UNITED STATES PATENT AND TRADEMARK OFFICE

Office Action Summary	Application No. 10/726,767	Applicant(s) NIXON, MARGARET MARIE	
	Examiner Michael G. Mendoza	Art Unit 3731

**FIG. 4**

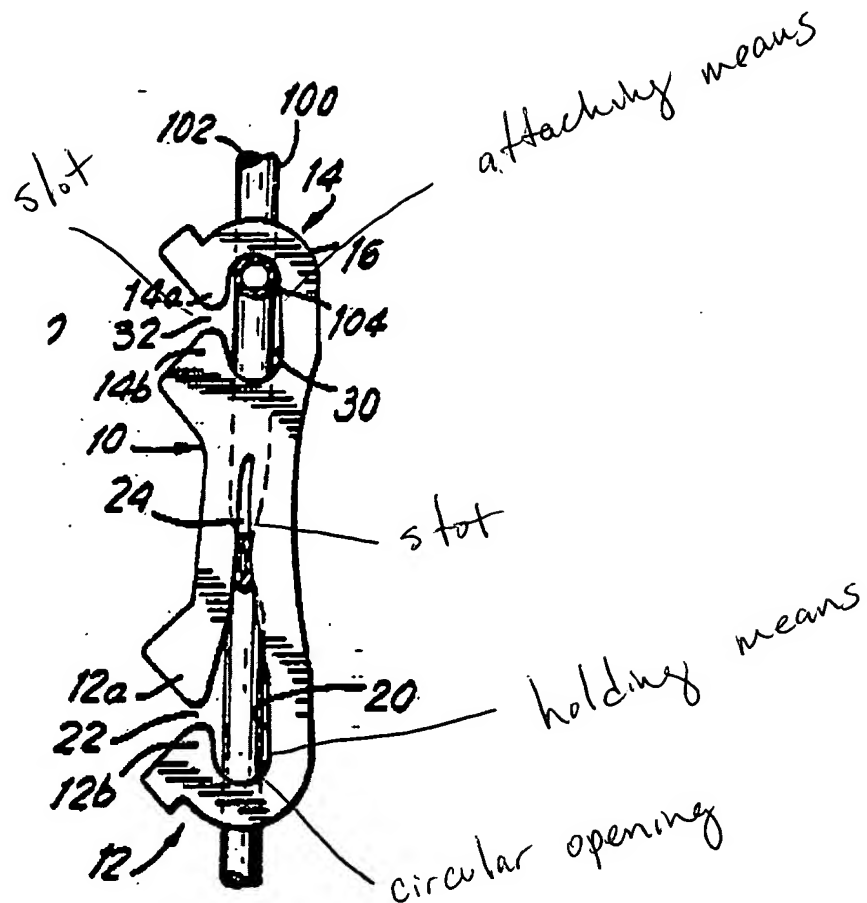
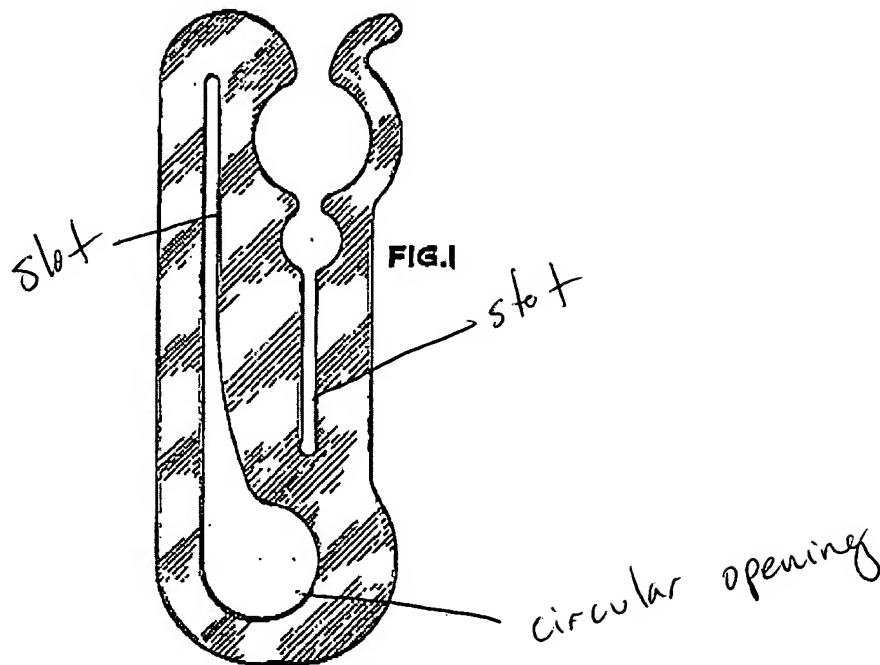
9. As to claims 11-13, Skakoon teaches a method of clamping, the method comprising the steps of: attaching a tension, having a body, to a length of surgical tape; passing a portion of the surgical tape around the elongated body structure; and securing the surgical tape in place by inserting a section of the surgical tape into a gripping portion of the tensioner; wherein the attaching step comprises securing a free end of the length of surgical tape in a slot in the tensioner; wherein the securing step comprises threading the length of surgical tape through an opening in the tensioner.

11. Lock teaches a tensioner for a surgical tape, the tensioner comprising a tensioner body having a first opening and a second opening passing therethrough; wherein the first section of the first opening has a circular cross-section; wherein the second section of the first opening is an elongated slot; and wherein the second opening is an elongated slot (see fig.).
